# Final
# Environmental Impact Statement

## for the
# Route 92 Project

## proposed by the
# New Jersey Turnpike Authority

## Comments and Responses
## Volume 1

(Mapleton Ave becomes Academy St-traffic between Rt 1 & Rt 27 Rank 92 attachment ①)

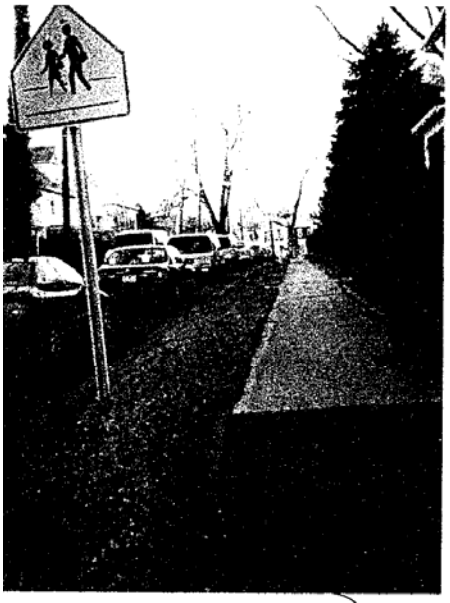
PS Picures of our traffic problems will accompany this letter.
